ADDENDUM NUMBER TWO (2)

Project: Health Sciences Complex (Rankin Campus)
Hinds Community College
Pearl, MS
HCC Bid #3298
PN: 21041

FROM: Dean Architecture, P.A.
661 Sunnybrook Road, Suite 140
Ridgeland, MS 39157
(601) 939-7717

Sheet
S203
 PILE CAP DETAILS

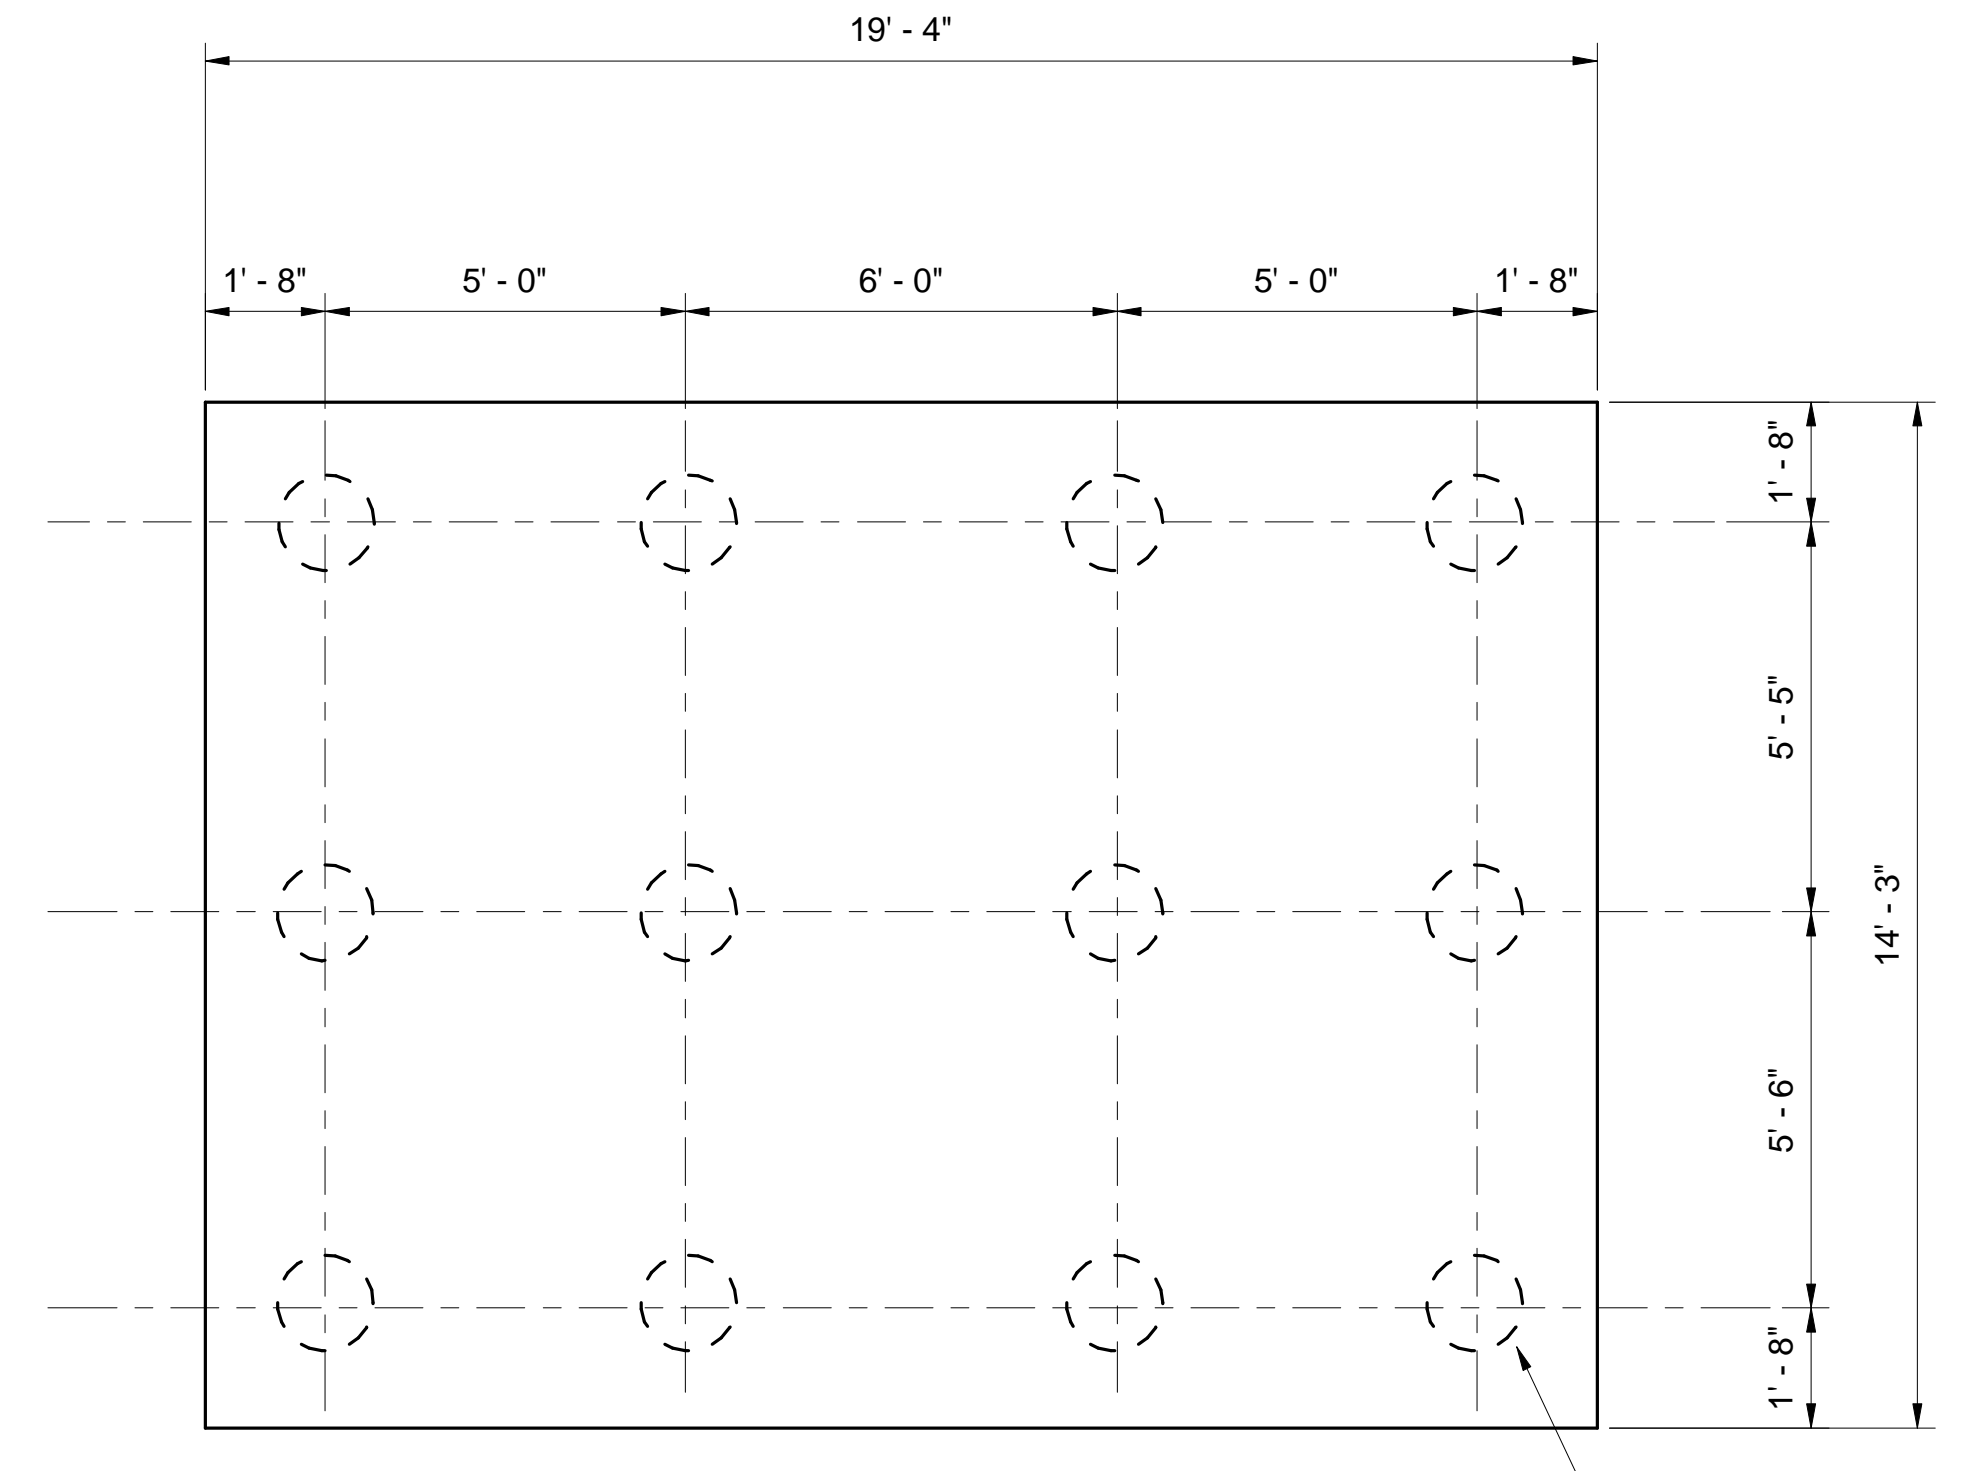
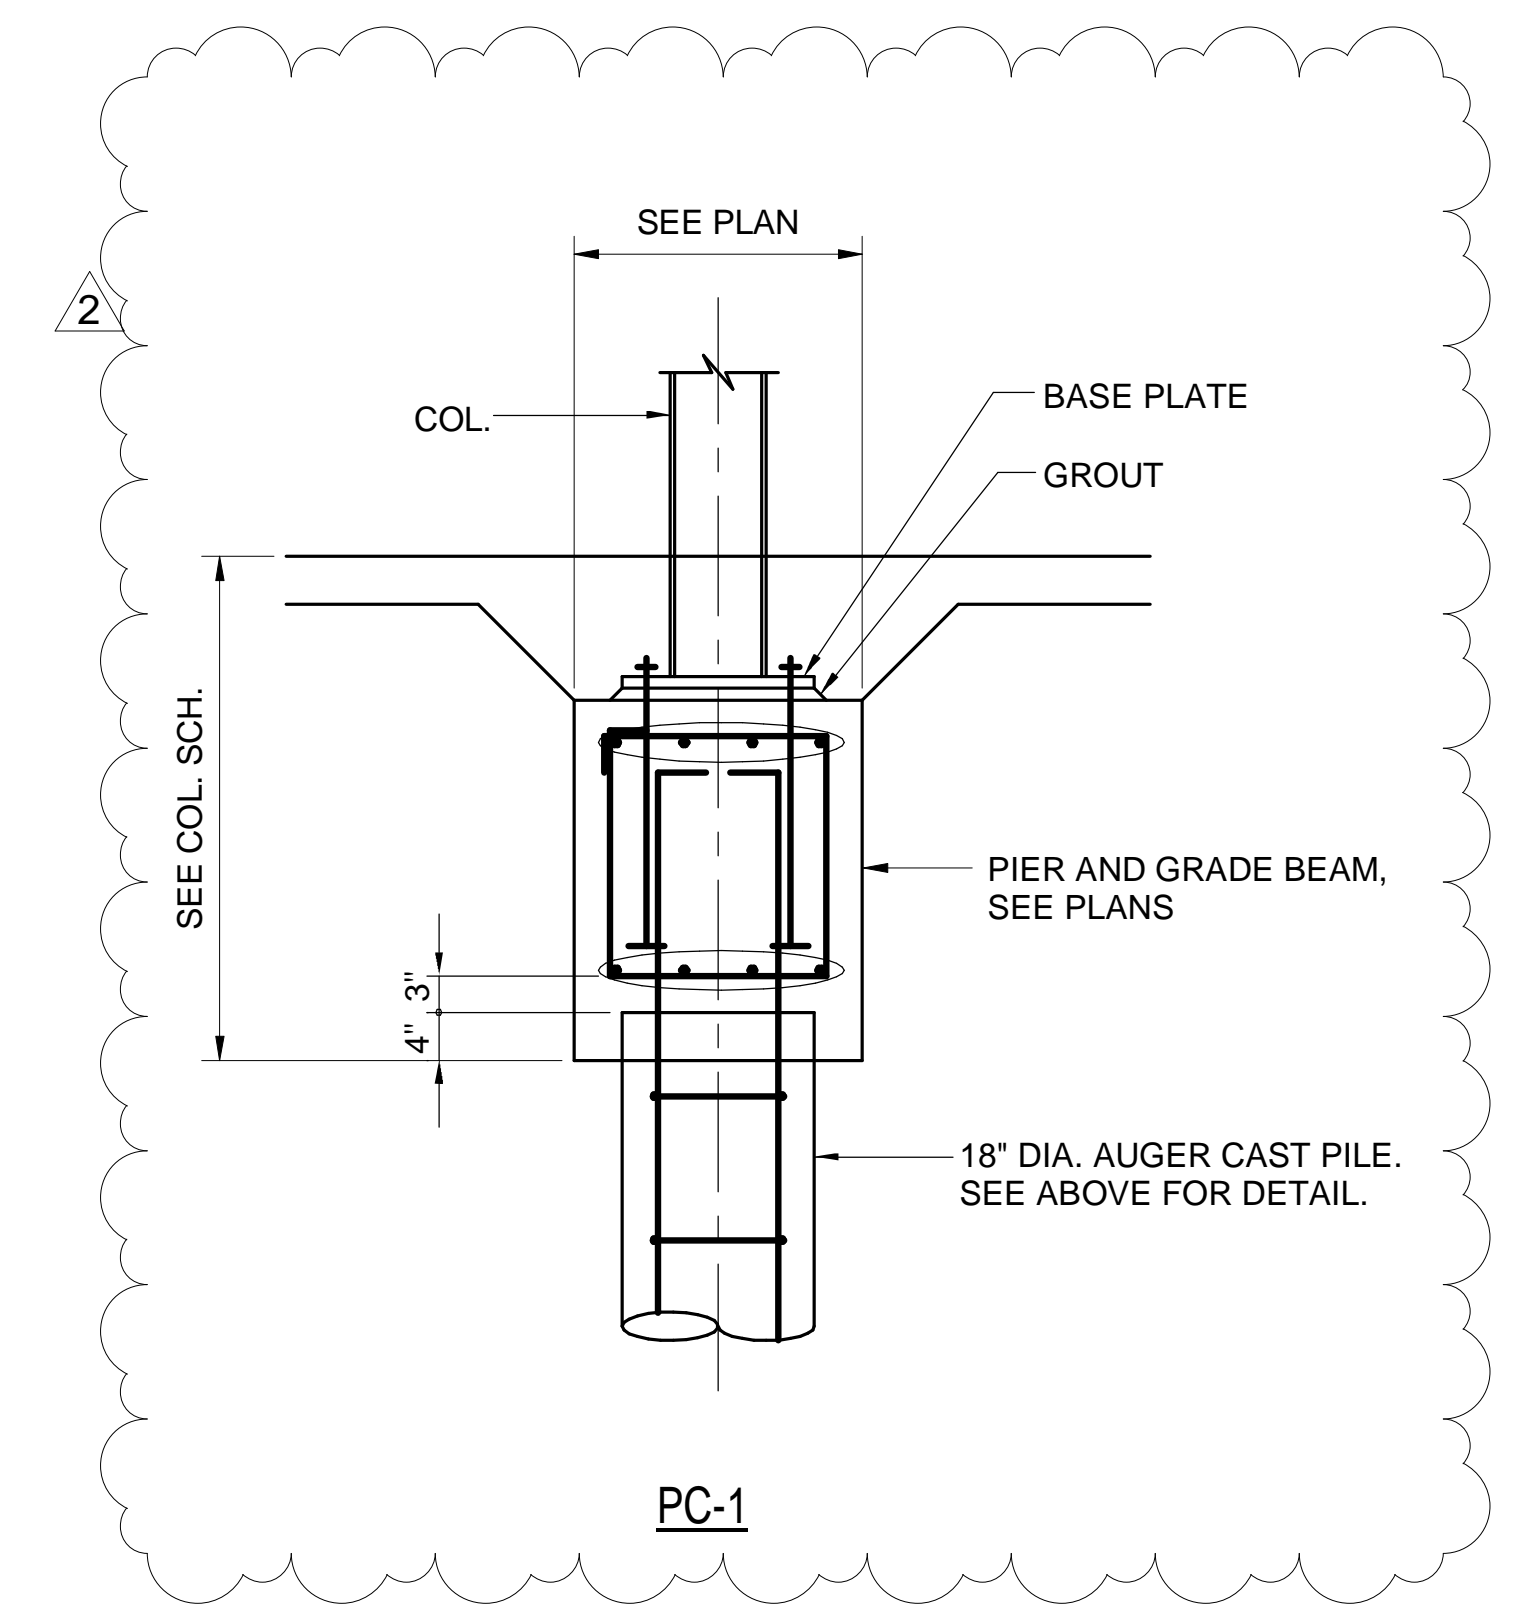
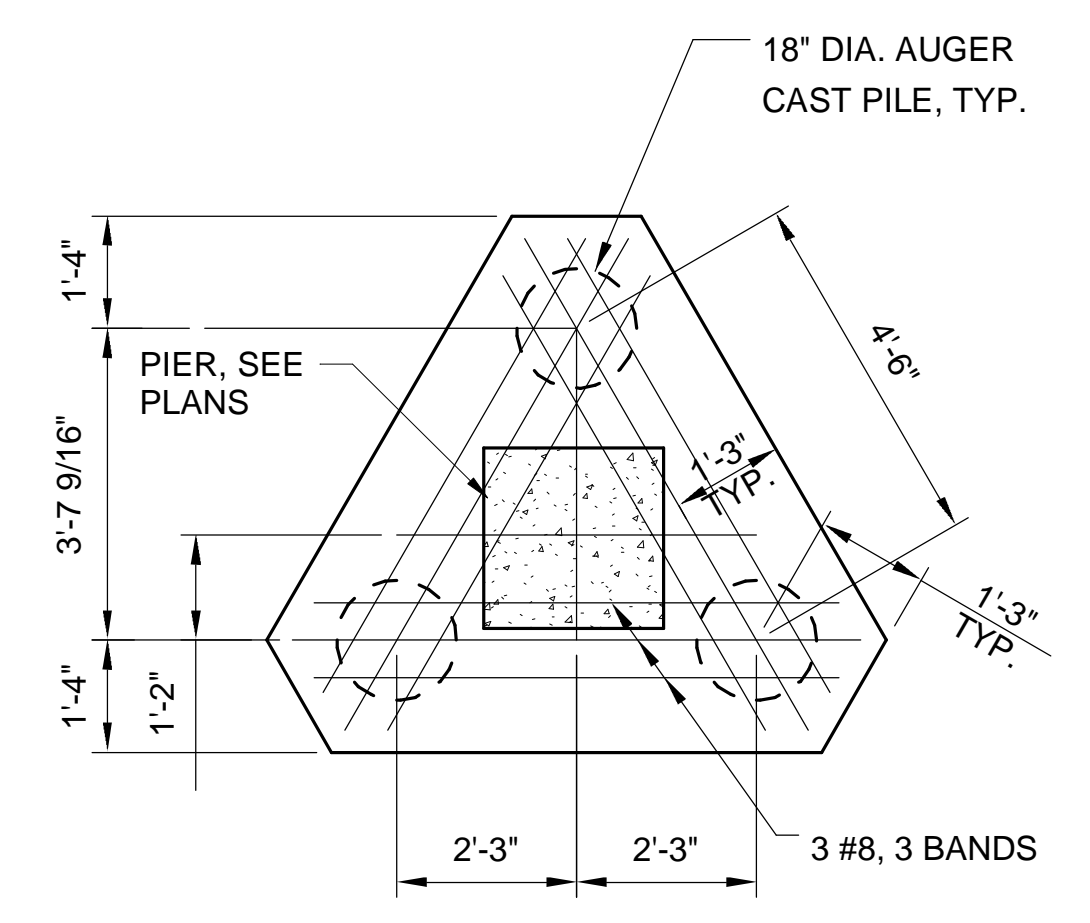
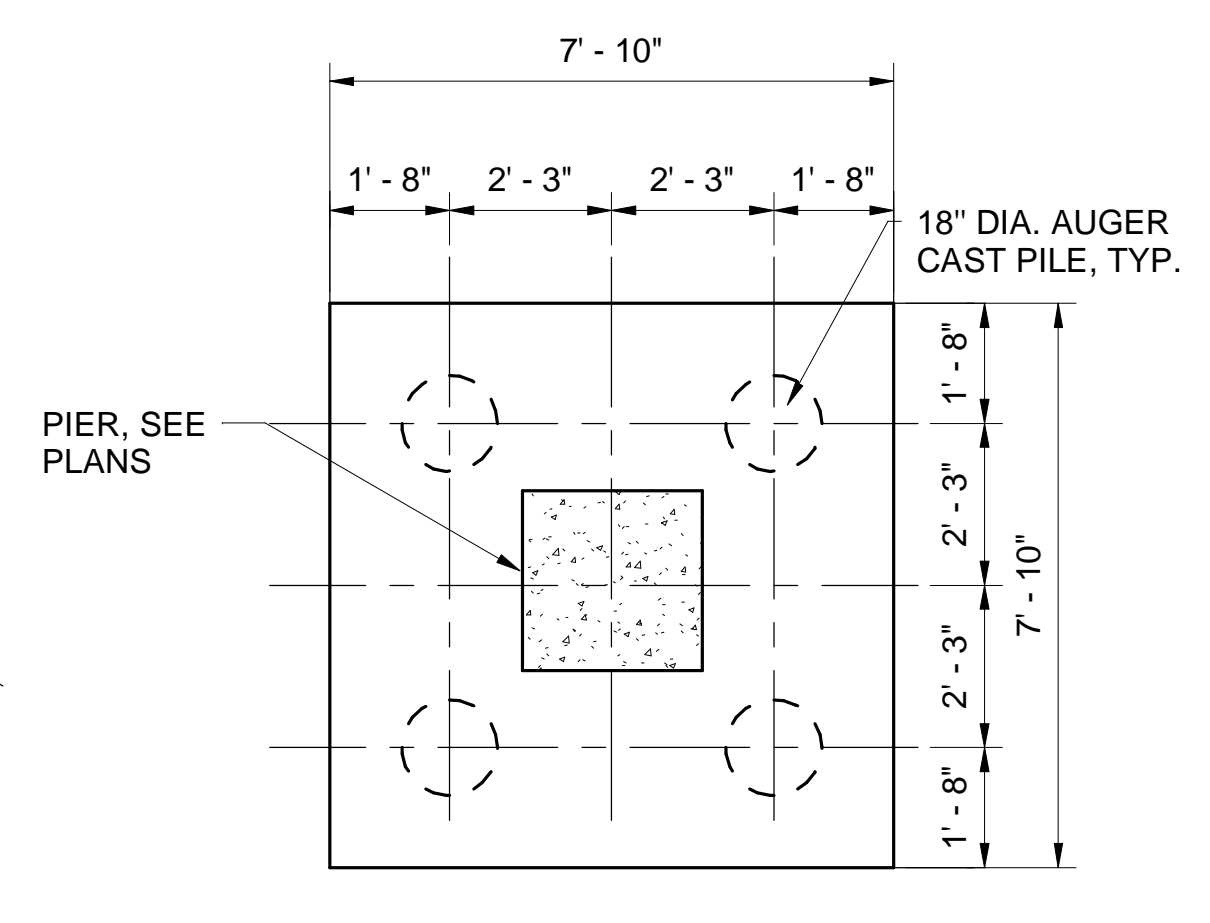
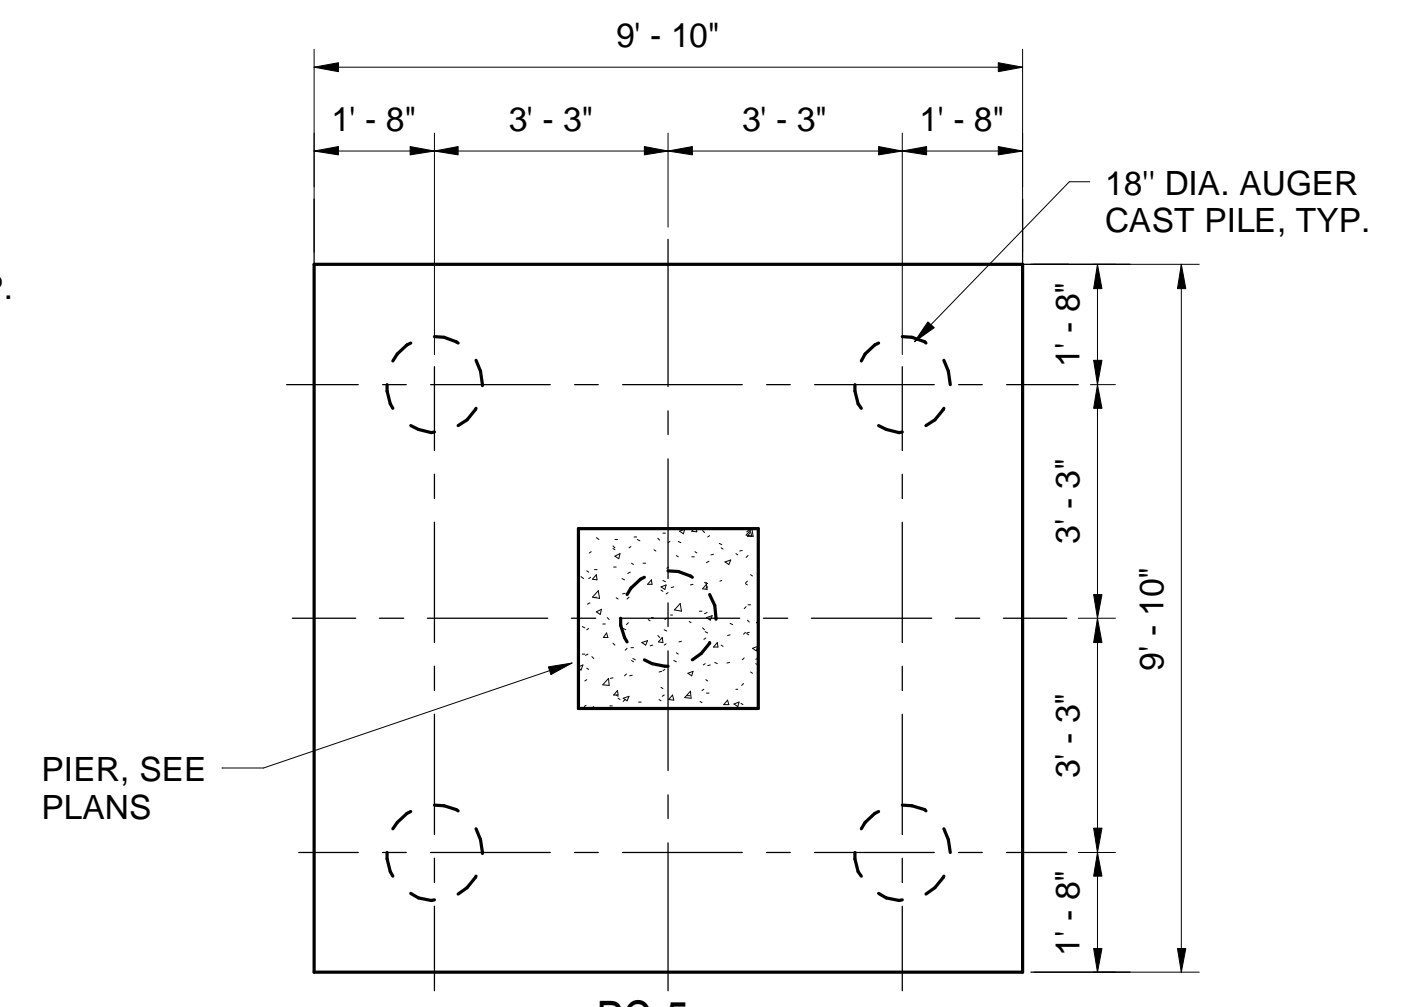
Item No. 1 Ref. Sheet S203 – Replace sheet S203 with attached sheet S203. (Revised PC-1)
